Stage 1 Road Safety Audit Report

Mayo County Council

Carrowrevagh Bridge

Stage 1 Road Safety Audit

Figure 2.1 - Safety Barrier Partially Obscuring Sight Lines at Private Accesses

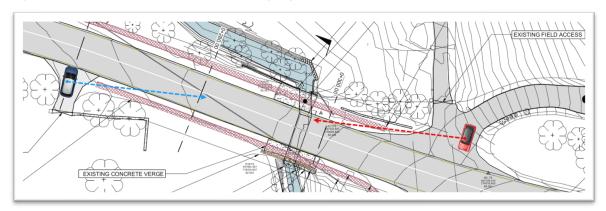
2.1 Problem: Safety Barrier Partially Obscuring Sight Lines

Location: Accesses on Either Side of Carrowrevagh Bridge

The proposed safety barrier may partially obscure drivers' sight lines at the field and house accesses on both sides of Carrowrevagh Bridge (see figure below), potentially increasing collision risks on the N59.

Assess sight lines at the accesses and adjust the safety barrier (if required) to optimize visibility.

2.1	Yes	Yes	Sightlines have been assessed with the end of the safety barrier on the southwest departure to be flared to avoid impact on sightlines from the field access. The sightlines from the domestic entrance northeast of the bridge location are not affected by the proposed barrier due to the relative ground levels at the location.	Noted.
